Access Compliance Report Public Rights-of-Way (Curb Ramps)

Main Street: S_SELLAS_RD Cross Street: WILDFLOWER Location: S

ADA ID: RPRK211103141349 Ramp Type: Type 4 - Parallel Initial Pass/Fail: Fail Overall Compliance: No Severity Score: 15

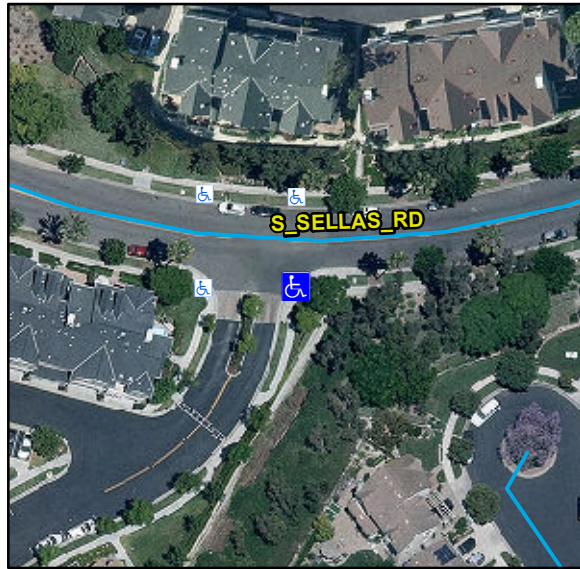
Compliance	Description	Data	Compliance	Description	Data
N/A	Ramp Length LT (in)	136	N/A	Ramp Length RT (in)	134
Yes	Ramp Width LT (in)	55	Yes	Ramp Width RT (in)	55
No	Ramp Run Slope LT (%)	8.6	Yes	Ramp Run Slope RT (%)	1.6
Yes	Ramp Cross Slope LT (%)	1.1	Yes	Ramp Cross Slope RT (%)	0.8
N/A	Landing Present	N/A	N/A	DWS Provided	N/A
N/A	Landing Length (in)	N/A	N/A	DWS Contrast	N/A
N/A	Landing Width (in)	N/A	N/A	DWS Length (in)	N/A
N/A	Landing Run Slope (%)	N/A	N/A	DWS Full Width	N/A
N/A	Landing Cross Slope (%)	N/A		DWS Offset Type	N/A
N/A	Landing Movement Obstructed?	N/A	N/A	DWS Offset Left (in)	N/A
	Landing Movement Type	N/A	N/A	DWS Offset Right (in)	N/A
N/A	Landing Shared	N/A			
N/A	Clear Space	Yes			
N/A	Clear Space To Crosswalk (in)	N/A			
N/A	Marked Crosswalk 1	No	N/A	Marked Crosswalk 2	No
	Crossing 1 Direction	N		Crossing 2 Direction	W
	Marked Crosswalk 1 Width (in)	N/A		Marked Crosswalk 2 Width (in)	N/A

Remove & Replace Curb Ramp With Two New Directional Ramps or Equivalent.

R204.3, R304.3.2, STD 1115
